DRAINAGE AND TRANSPORTATION INFORMATION SHEET (DTIS)

Traffic Scoping Form (REV 07/2020)

Project Title: The 66

THE SIXTY-SIX
4501 CENTRAL AVE NE
ALBUQUERQUE, NM 87108

SITE PLAN

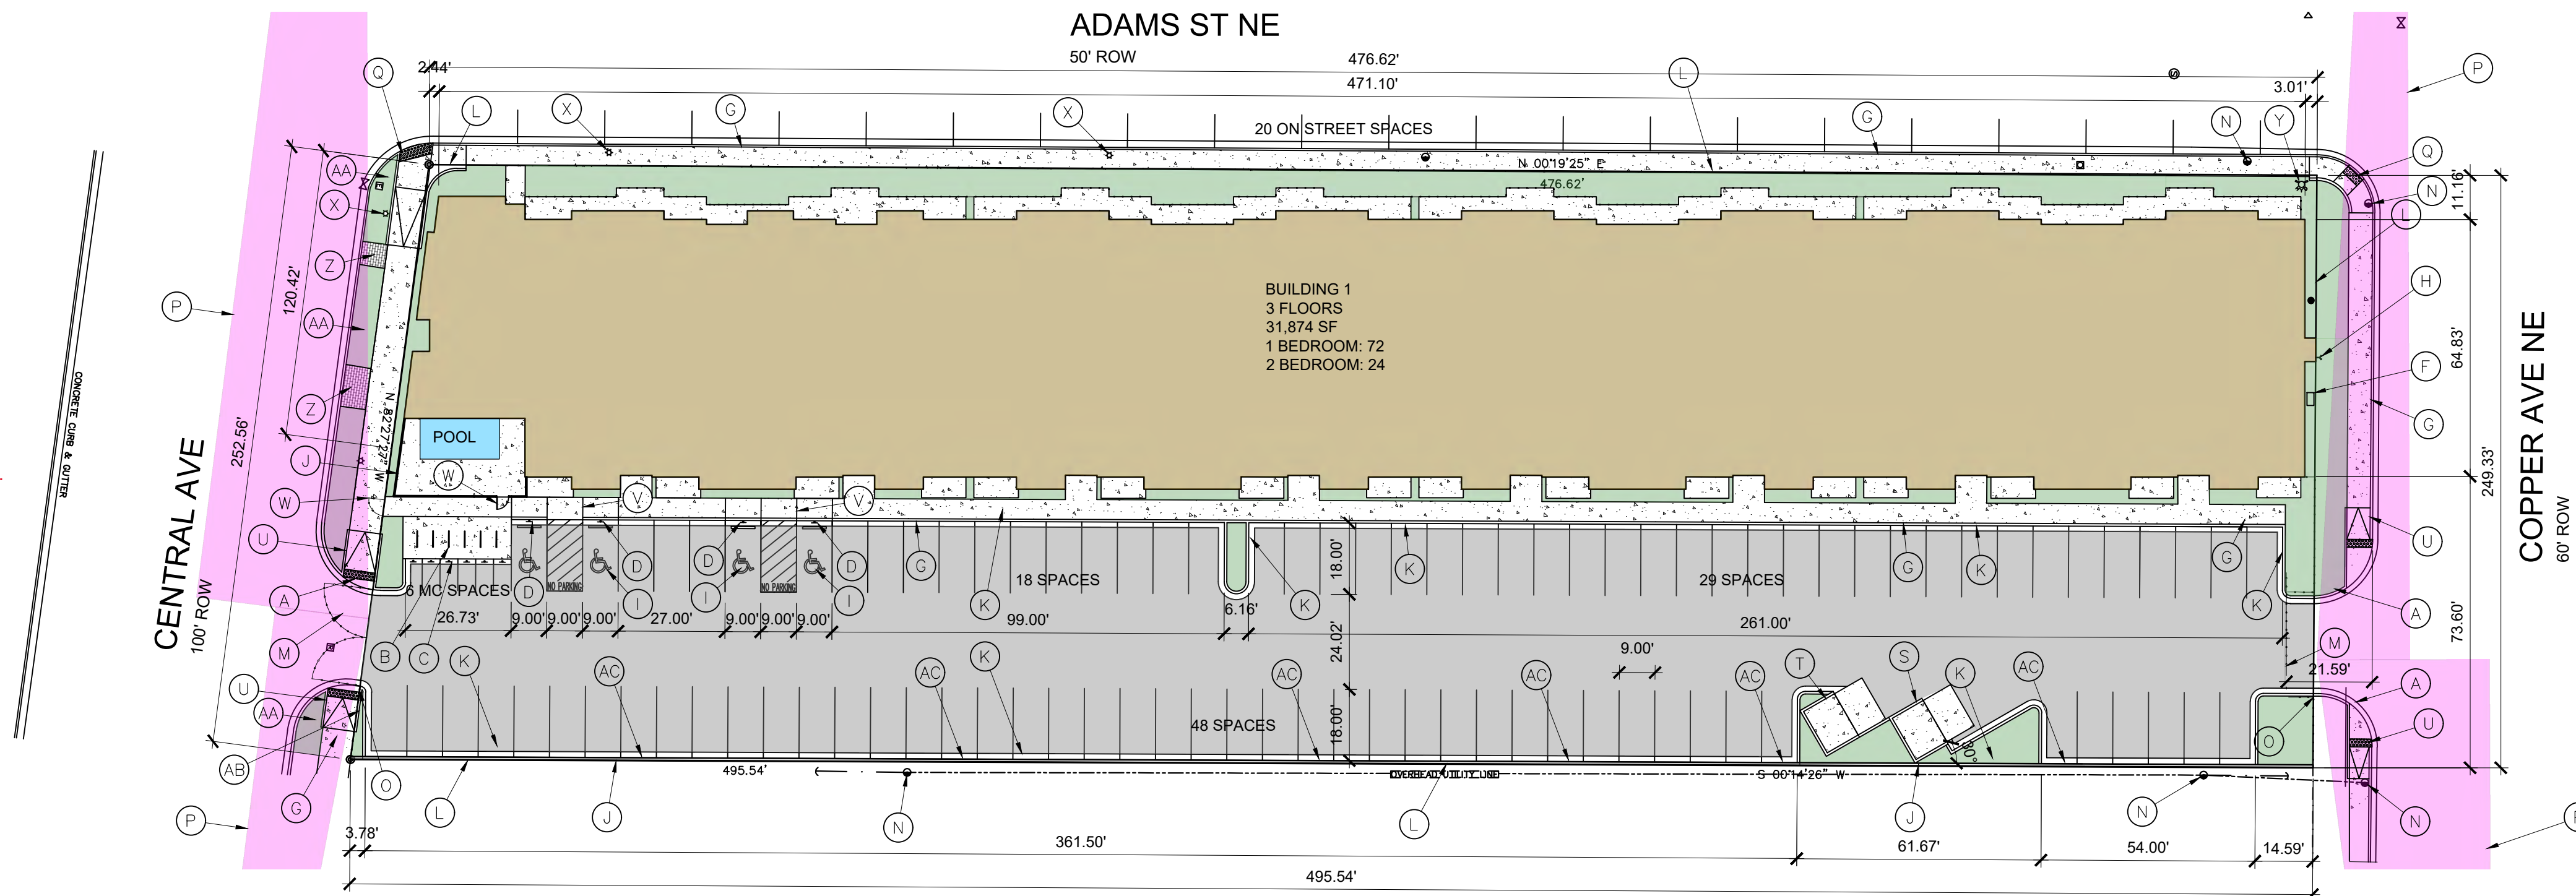
Approved for access by the Solid Waste Department for a double trash enclosure. The refuse and recycle driver will be given gate clickers for the gates off of Copper. *The owner of this property will have to purchase an 8-cubic yard dumpster for trash.** Herman Gallegos 03-13-23 *Herman Gallegos*
